# Torrance Transit Park and Ride Regional Terminal

Bidder's Submittal Forms

November 22, 2017

- 2) Reference part of Drawing Sheet EY600 (see next page).**

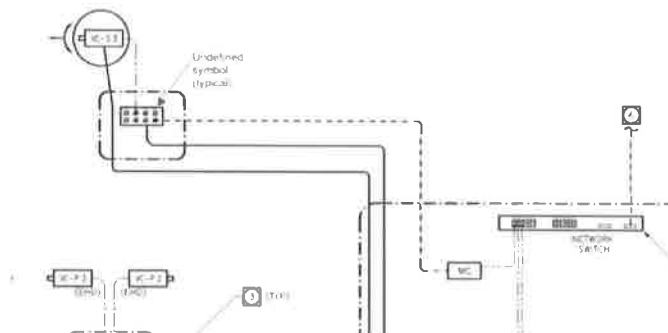
There is an undefined symbol on the single line drawing. Is this a hardened network switch? Is it to be provided by the City IT (like the other network hardware)?

**A6b:** The referenced device in the drawing attached to the Bidder's RFI (partial, marked up portion of plan shown above) is a hardened outdoor rated switch. It is specified in Section 282300, Article 2.2, Paragraph B.
